**CITY OF RAYMORE**

**ADDENDUM NO. 1**

2021 Sidewalk Project

Project #21-381-201

Project Map  
Not to Scale

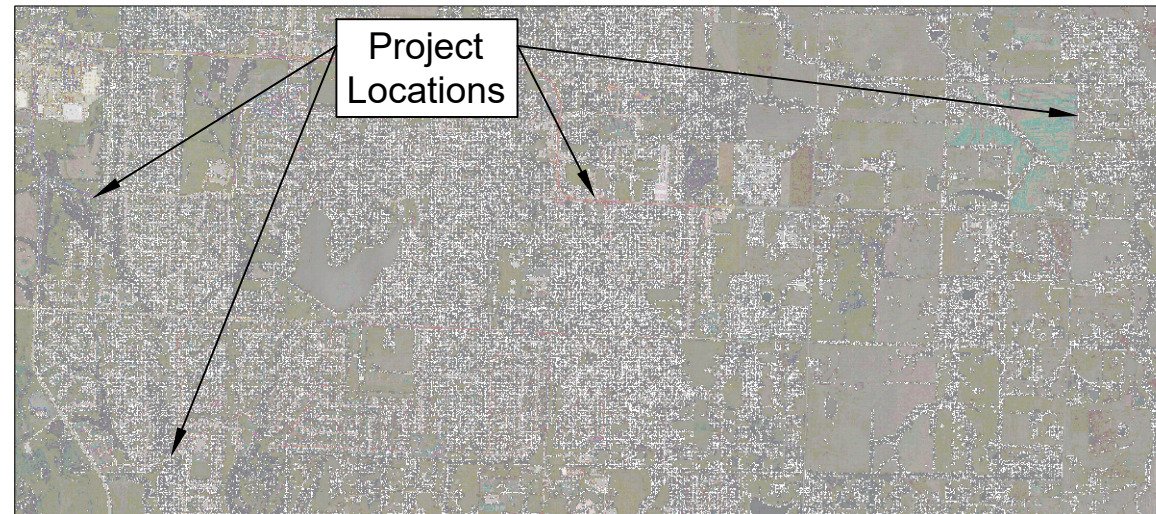
- Added project locations to the first map page
- Added quantities for each individual road to the corresponding plan page
